TOWN OF MILTON
PLANNING AND DEVELOPMENT
JUNIPER 7 MODEL

BUILDING: REVIEWED
SCOTT SHERRIFFS APR 13, 2017
PLANS EXAMINER DATE

JUNIPER 7
ENERGY STAR

PROJECT NAME
LECCO RIDGE

LEFT ELEVATION 2

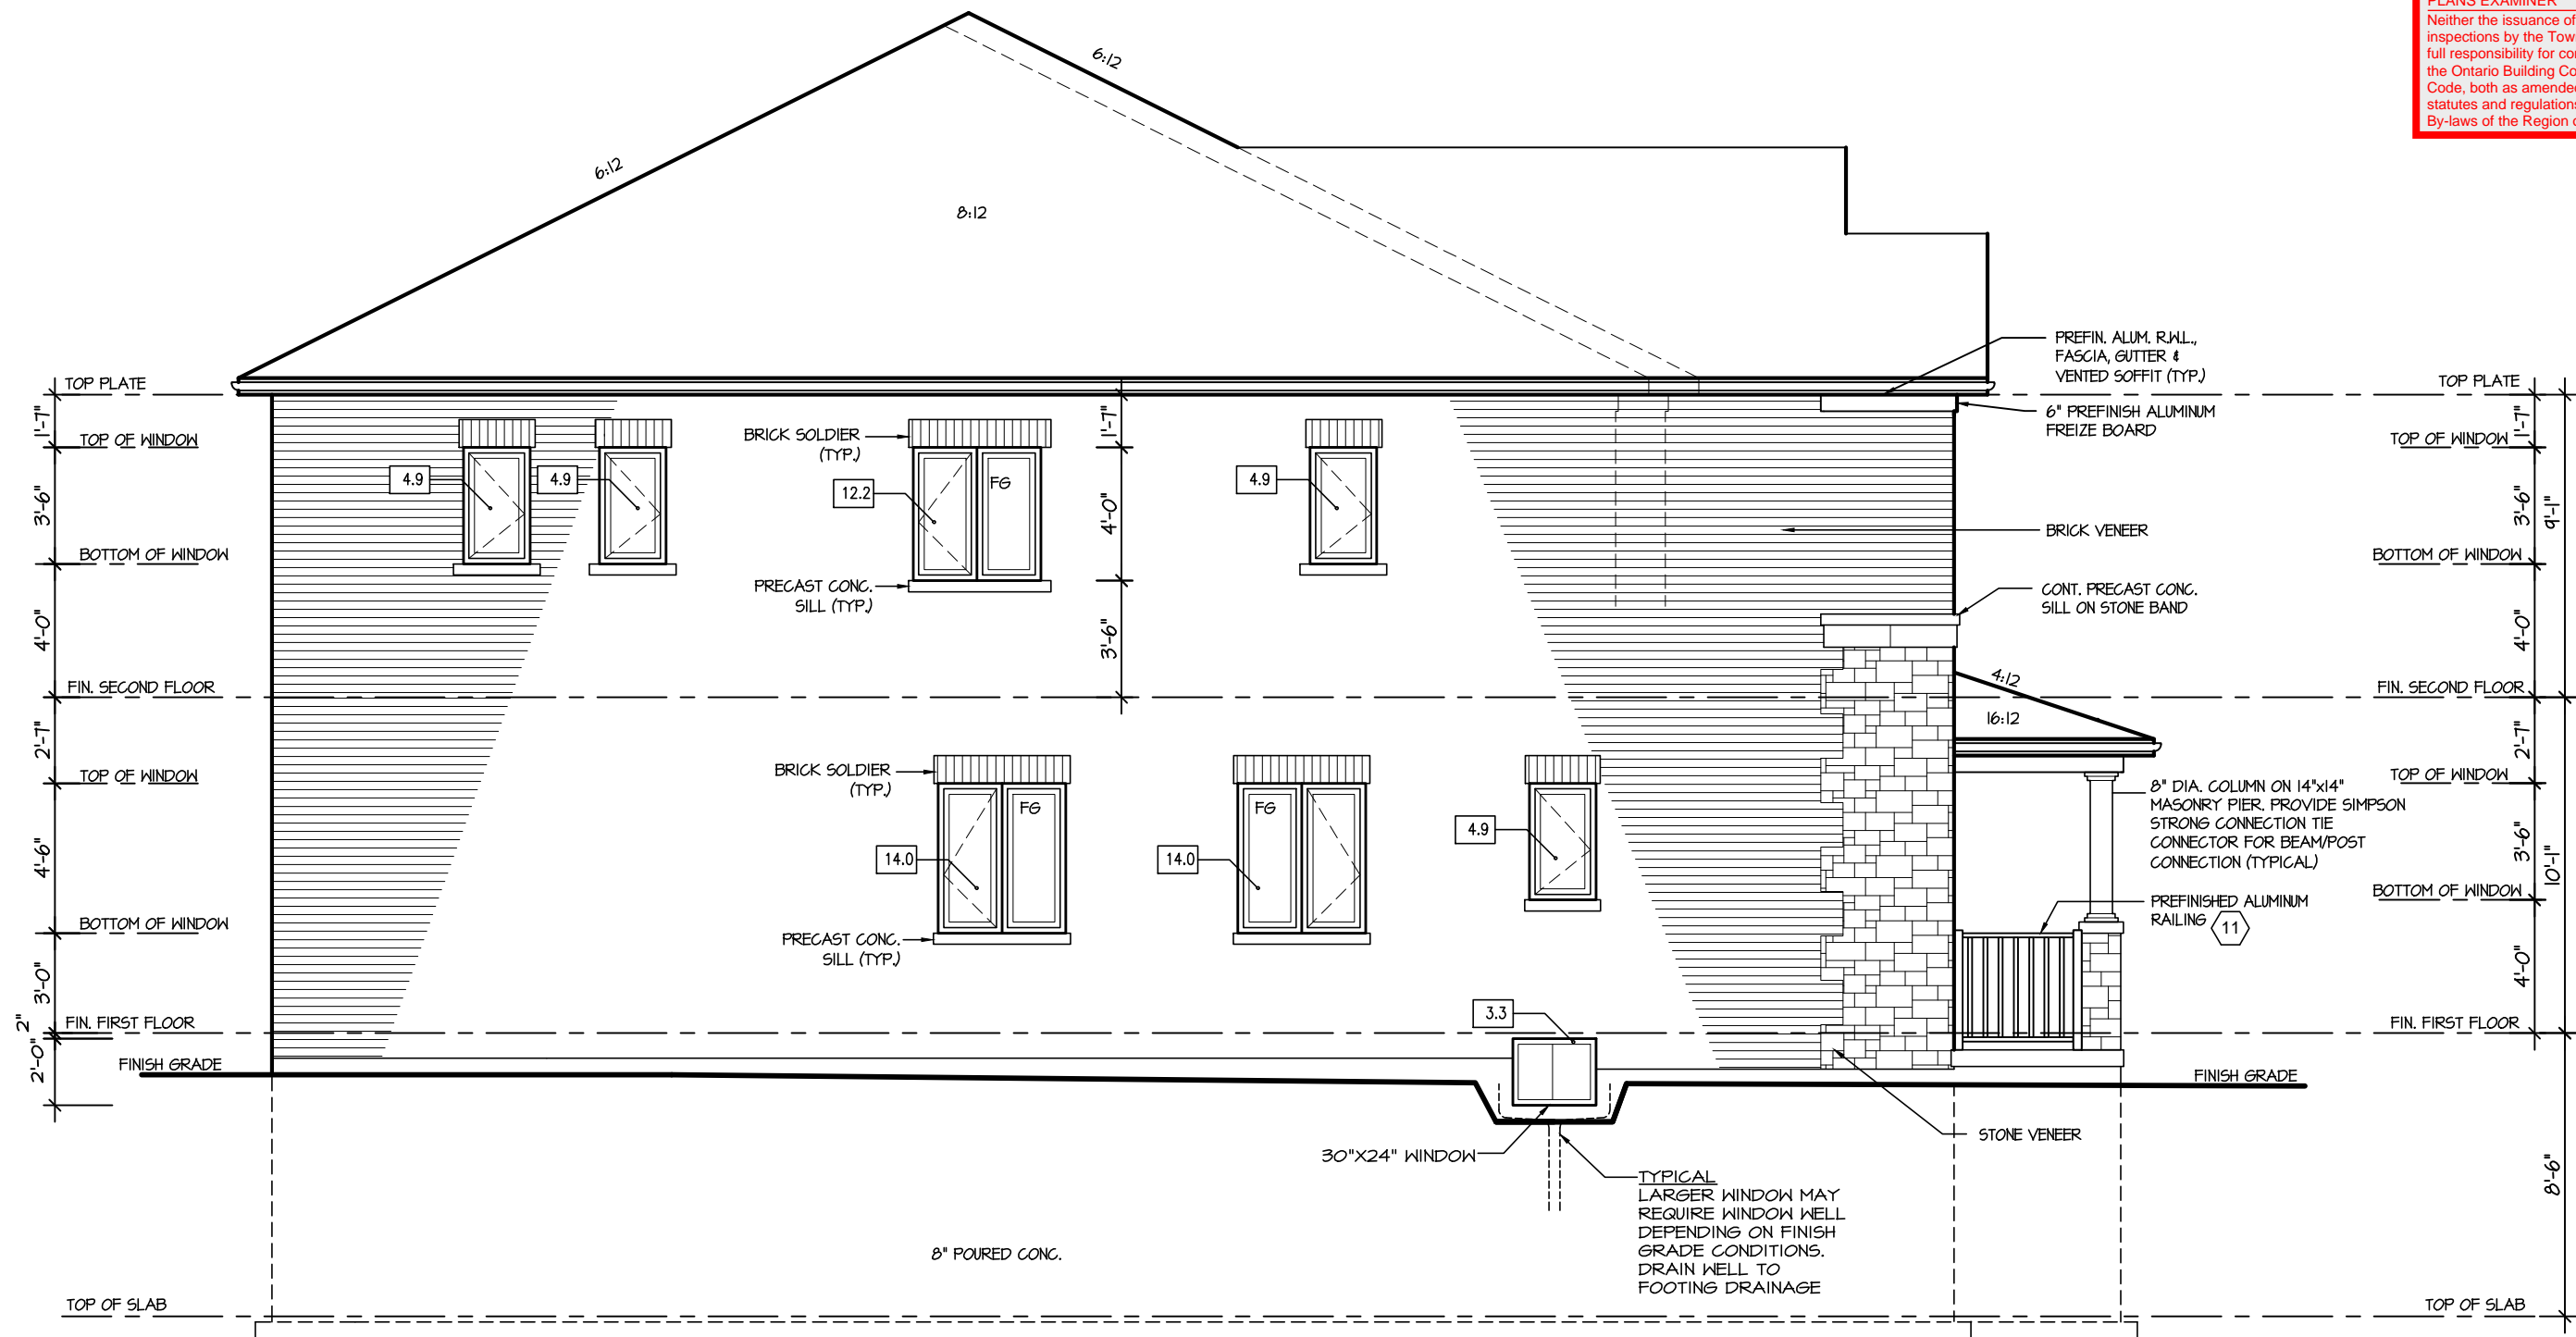
ALLOWABLE GLAZING (STANDARD PLAN)			
WALL AREA	=	1039	Sq. Ft.
ALLOWABLE GLAZED AREA @ 1 % 1.2 M SIDE YARD	=	12.73	Sq. Ft.
ACTUAL GLAZED AREA	=	63.1	Sq. Ft.

SHEET TITLE WALK-UP PLANS	
SCALE 3/16"=1'-0"	BY ZMP
DATE JAN 2017	TYPE

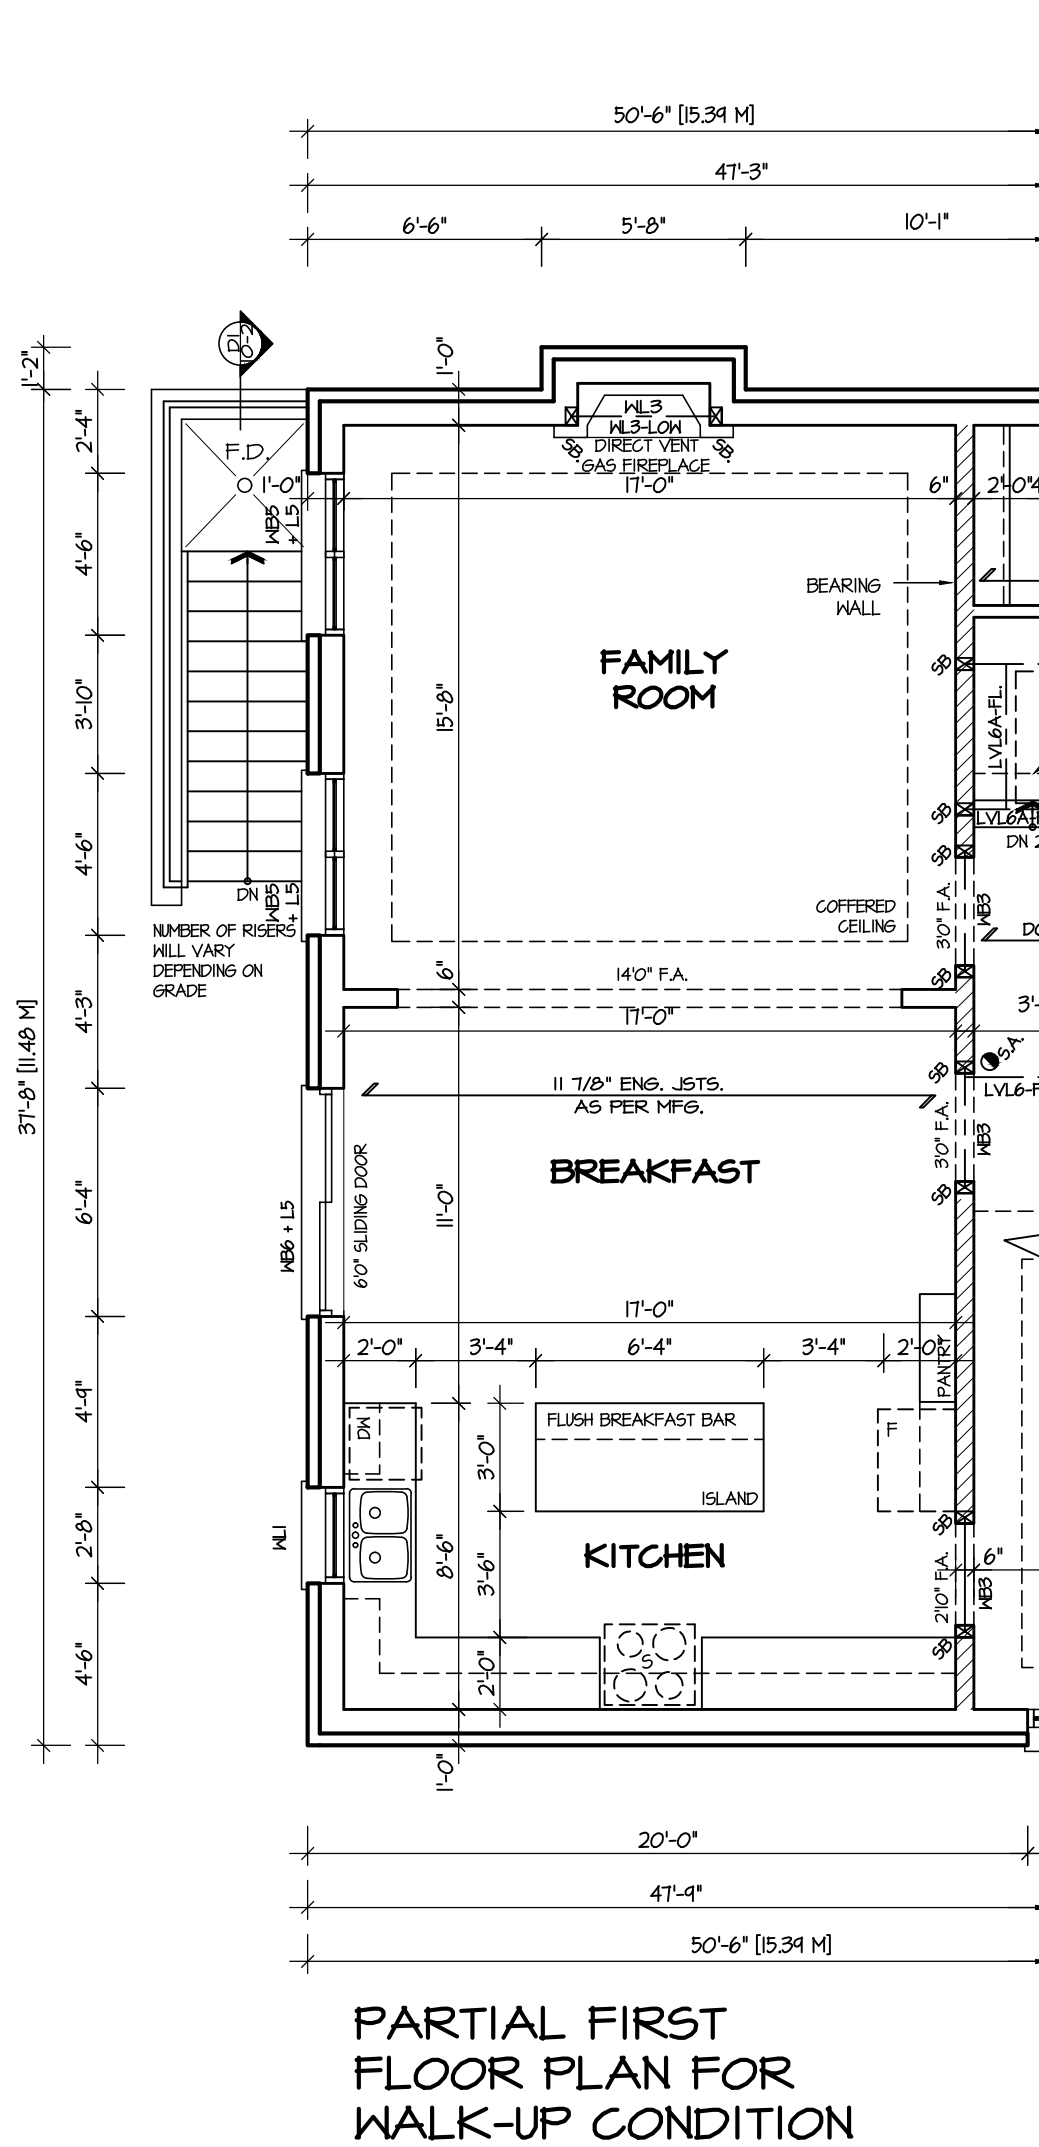
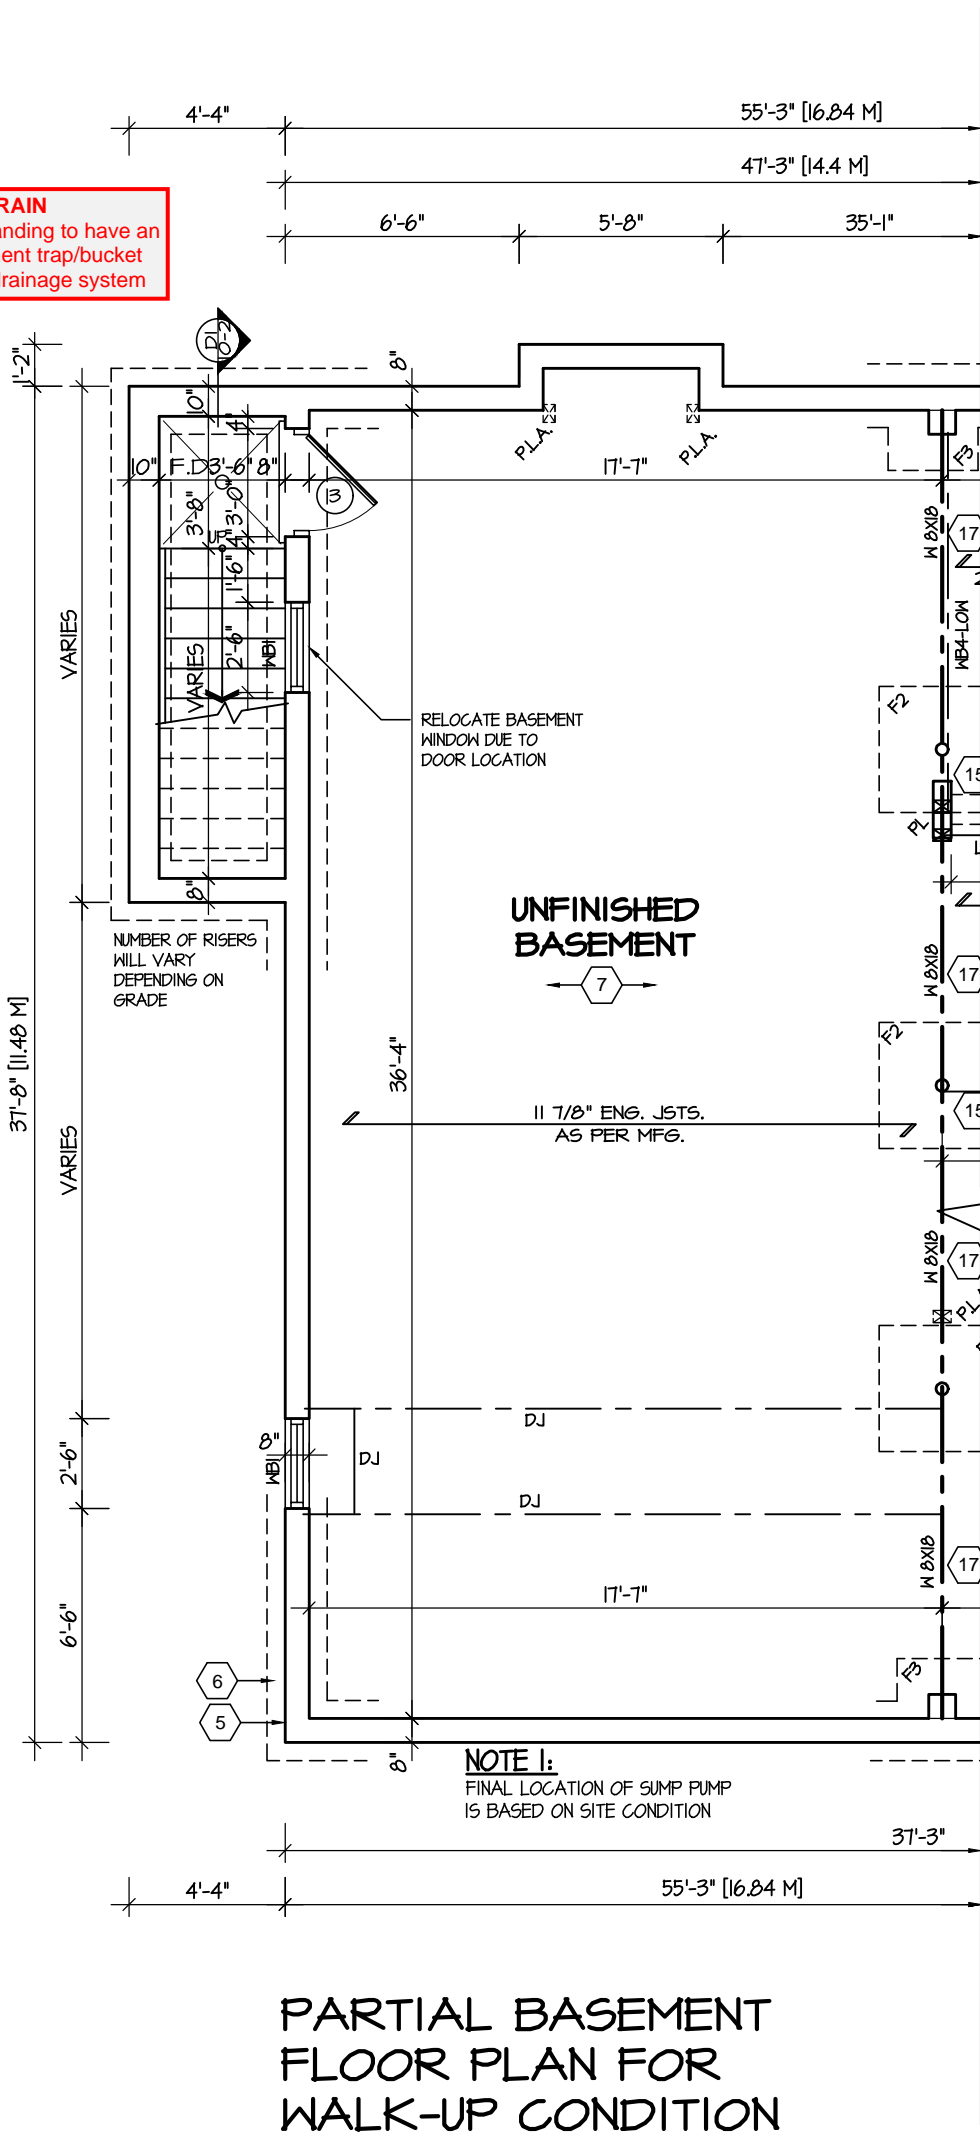
WALKOUT AREA DRAIN
Uncovered walkout landing to have an area drain with sediment trap/bucket connected to Storm drainage system

WALKOUT BSMT. INSULATION
See standard details page 12 for required perimeter slab insulation for walkout basement condition
